Access Compliance Report

Public Rights-of-Way

Intersection ID: 9397	Main Street: LAKE_DR	Cross Street: THE_PLAZA	Location: SE
ADA ID: 70B6A47B7D44	Ramp Type: BlendTrans1	Initial Pass/Fail: Fail	Overall Compliance: No
		Severity Score: 1.25

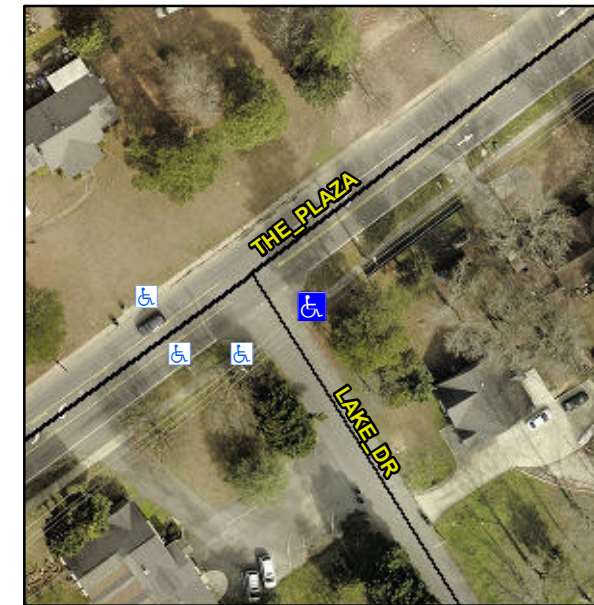
Surveyor Notes:

NO CURB

R304.5.3

Compliance	Description	Data	Compliance	Description	Data
N/A	Ramp Length (in)	56.0	Yes	BlendTrans Slope (%)	1.9
Yes	Ramp Width (in)	59.0	No	BlendTrans XSlope (%)	3.3
N/A	Flare Type LT	N/A	N/A	Flare Type RT	N/A
N/A	Flare Slope LT (%)	N/A	N/A	Flare Slope RT (%)	N/A
N/A	Flare Traversable LT?	N/A	N/A	Flare Traversable RT?	N/A
N/A	Landing Length (in)	N/A	N/A	DWS Provided?	N/A
N/A	Landing Width (in)	N/A	N/A	DWS Contrast?	N/A
N/A	Landing Slope (%)	N/A	N/A	DWS Length (in)	N/A
N/A	Landing X Slope (%)	N/A	N/A	DWS Full Width?	N/A
N/A	Landing Curb? (Y/N)	N/A	N/A	DWS Offset (in)	N/A
N/A	Shared Landing?	N/A			
N/A	Gutter Ponding?	N/A	N/A	Gutter Slope (%)	N/A
N/A	Gutter Lip Ht (in)	N/A	N/A	Gutter X Slope (%)	N/A
N/A	Painted X Walk1?	No	N/A	Painted X Walk2?	N/A
	X Walk 1 Direction	To SW		X Walk 2 Direction	N/A
	X Walk 1 Width (in)	N/A		X Walk 2 Width (in)	N/A
	X Walk 1 Slope (%)	2.7		X Walk 2 Slope (%)	N/A
	X Walk 1 X Slope (%)	6.9		X Walk 2 X Slope (%)	N/A

Remove & Replace Curb Ramp With Two New Directional Ramps or Equivalent.
